RE: 15600 Marchmont Drive

I reviewed the drawings and evaluated the neighborhood context. My comments and recommendations on the design are as follows:

Proposed Front Elevation

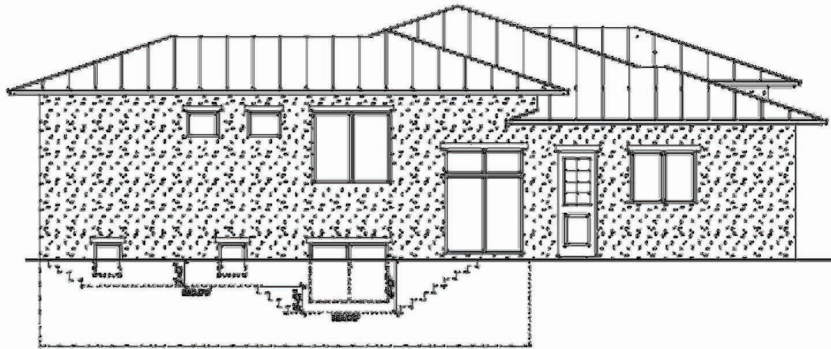
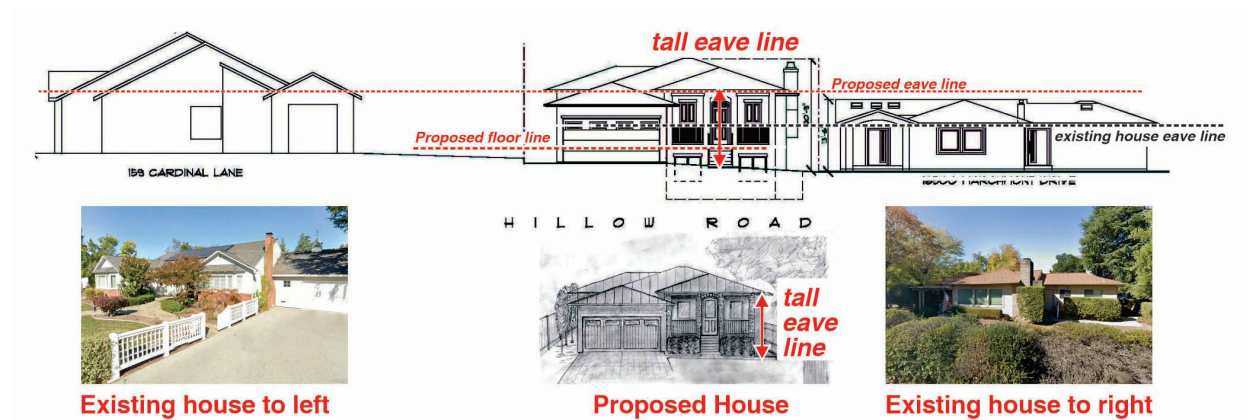
1. While the overall height of the house would be limited by virtue of the partially below grade configuration. The eave line would be considerably higher than other homes in its immediate neighborhood. That would not be consistent with Residential Design Guideline 3.3.2.

5. The windows appear to be set in to the wall without trim which would not be consistent with Residential Design Guideline 3.7.4.

- *Most architectural styles - except Mission, Spanish Eclectic or Modern - should have wood trim around the windows. The trim width should be matched to the style, but in general, should not be less than 3 1/2 inches wide. Head trim depth should be equal to or wider than the jamb casing, but not less than one-sixth of the opening width.*
 - *Projecting window sills and heads are strongly encouraged unless the architectural style would not normally have those features.*
 - *Wood trim is also encouraged on stucco houses unless the window frames are recessed at least 6 inches from the outside face of the wall. The use of stucco covered foam trim is strongly discouraged.*
6. The columns on the rear facade are too small for the scale of this house.

5. Add trim at all windows to be consistent with Residential Design Guideline 3.7.4.

6. Increase the size of the columns on the rear facade.

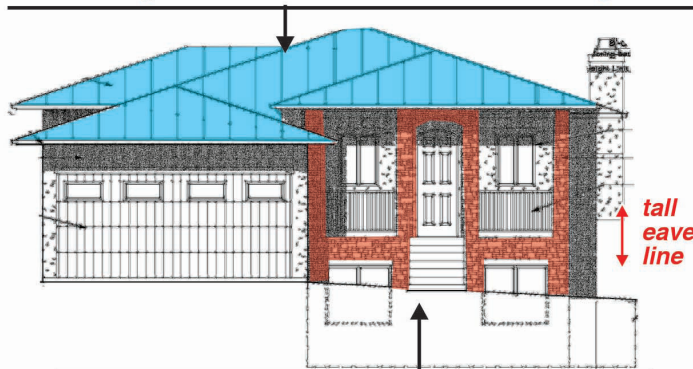
2. The stone proposed for the front facade porch is not carried consistently around the other home facades. This would not be consistent with Residential Design Guideline 3.2.2.

Metal roofing would be out of character with this neighborhood

Use of stone on the front facade without carrying it consistently around all sides of the house would not be consistent with Residential Design Guideline 2.2.2

- **Eliminate the stone.**
- **Design the porch to be consistent with Residential Design Guideline 3.10.1.**

2. Select a roofing material that is more consistent with the material, color and texture of other homes in the immediate neighborhood.
3. Recess the garage door to be consistent with Residential Design Guideline 3.4.1.

3.10.4 Chimneys

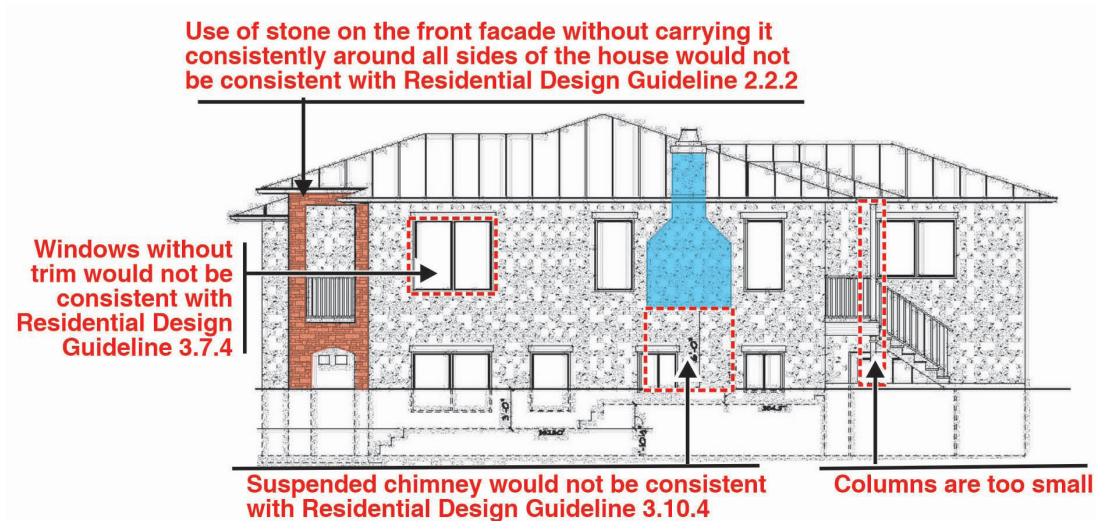
3. The proposed metal roofing would be out of character with this neighborhood.
- 4.. The chimney is suspended on the side facade without extending to grade which would not be consistent with Residential Design Guideline 3.10.4.

- *Chimneys should extend to ground level. Avoid cantilevers above the ground.*

4. Extend the chimney to grade consistent with Residential Design Guideline 3.10.4.

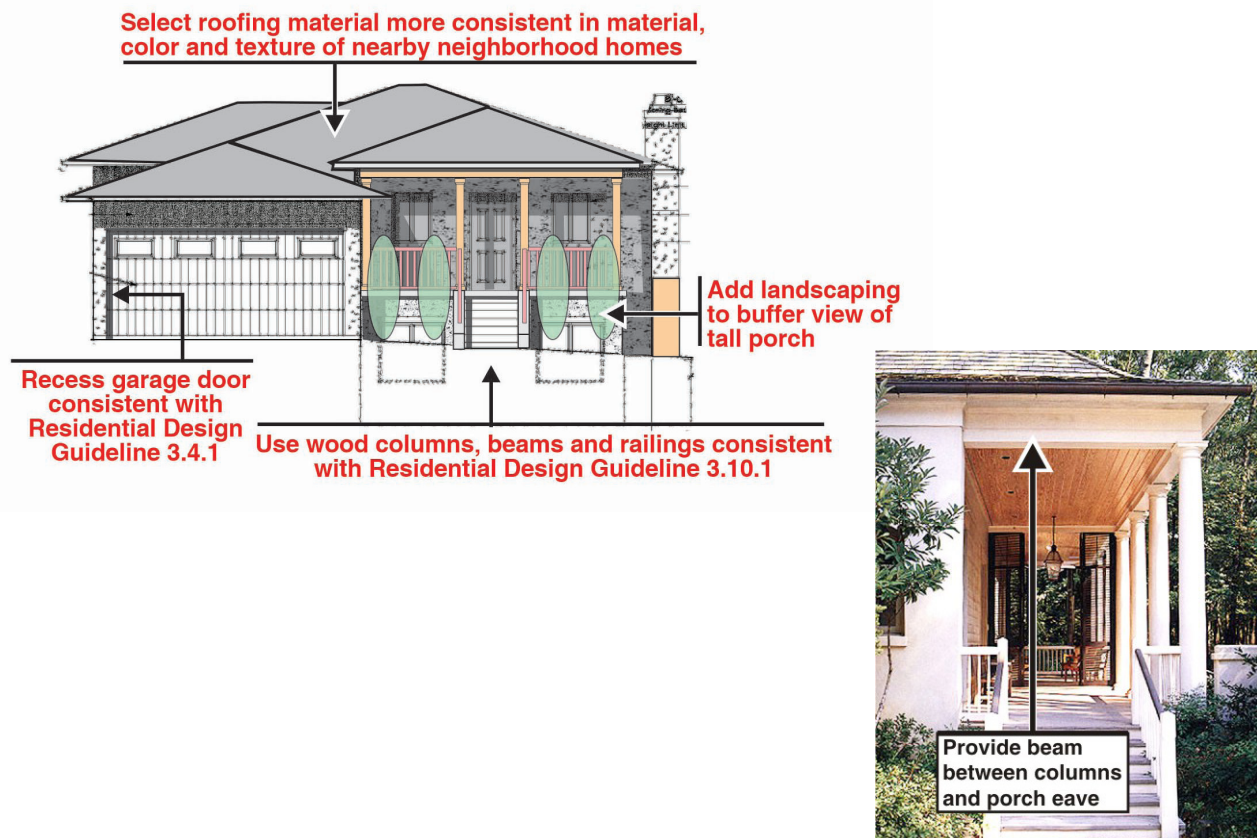
1. Redesign the entry porch to be compatible with other homes in the neighborhood. Recommendations include:

- Add landscaping to buffer the view of the tall porch eave line.

3.4.1 Limit the prominence of garages

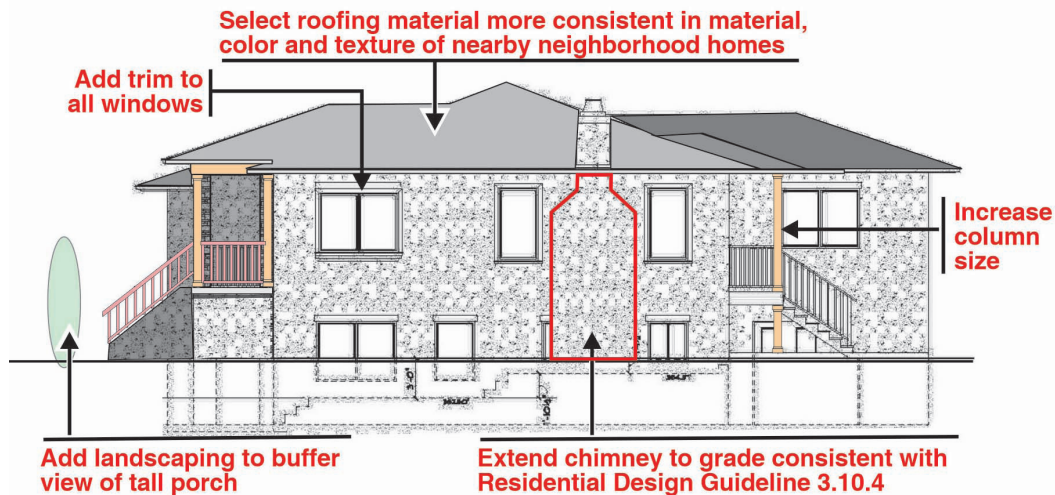
- *Recess garage doors as much as possible from the garage facade.*
